**CITY OF TEMPE
DEVELOPMENT REVIEW COMMISSION**

Meeting Date: 12/08/2015
Agenda Item: 9

BACKGROUND INFORMATION: CRESCENT RIO (PL150283) is a proposed 90'-0" high, mixed-use building containing 356 dwelling units and 5 live-work units. AN AFFIRMATIVE VOTE BY AT LEAST TWO-THIRDS (2/3) OF THE CITY COUNCIL IS REQUIRED TO APPROVE THE GENERAL PLAN DENSITY MAP AMENDMENT. The request includes the following:

**General Plan 2040 Density:
Medium-High**

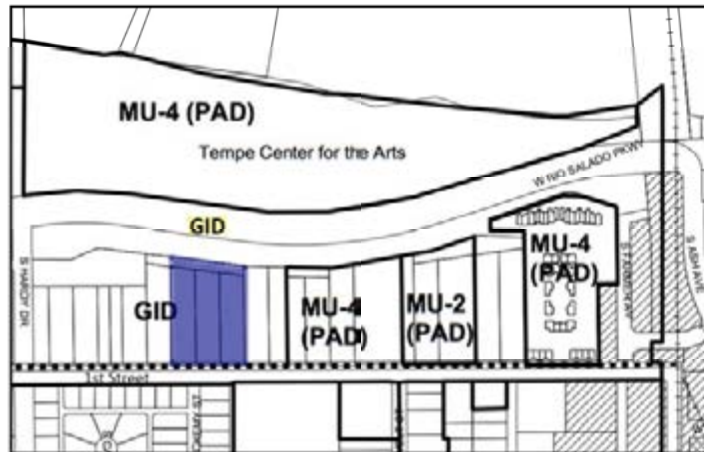
The existing General Plan projected residential density for this site is Medium to High Density (up to 25 du/ac). See the existing General Plan 2040 Projected Density Map of the area below.

The requested density of 112 du/ac would require an amendment to the High Density-Urban Core category (more than 65 du/ac). The Projected Density map identifies areas intended for High Density-Urban Core development as generally south of the Loop 202, north of Apache Boulevard, east of the railroad tracks, and west of Dorsey Lane. These areas are along the Light Rail Transit corridor and within a Land Use Hub that includes the Town Lake District, Downtown/Mill Avenue District, and ASU/Stadium District. See Attachment 3 for General Plan 2040 Figure 3 Land Use Hubs.

The proposed density is not aligned with the General Plan objectives. Land Use Goal Objective LU1 is to “Establish development of multiple hubs with higher density cores serving the surrounding neighborhoods as its mixed-use urban activity center.” The first strategy of this objective is to “Intensify higher density mixed-use redevelopment within hubs.” The request ignores the intent of the land use hubs to encourage that the highest density developments be concentrated in the downtown. Objective LU3 is “seek balance and compatibility of new land use development with established residential neighborhoods.” There are no developments along 1st Street and west of Ash Avenue are designated as more than 65 du/ac. The majority of properties on the north and south sides of 1st Street are designated as up to either 15 du/ac or 25 du/ac. Developments along 1st Street, between Farmer Avenue and Hardy Drive are the 525 Town Lake Condominiums and Regatta Pointe Condominiums, both with a density category of up to Medium to High Density (up to 25 du/ac). The only exceptions along 1st Street are Skywater at Town Lake (formerly Argo at Town Lake) and recently approved Broadstone Lakeside, with density categories of up to 65 du/ac. Though all sites are reviewed on a case-by-case basis, approval of a development on 1st Street with a density of more than 65 du/ac could encourage higher density developments in the future and lose track of the intended mid-range residential density planned for this neighborhood.

1. The General Plan Projected Density Map Amendment request from Medium to High Density (up to 25 du/ac) to High Density-Urban Core (more than 65 du/ac) is denied; instead an amendment to High Density (up to 65 du/ac) is approved.
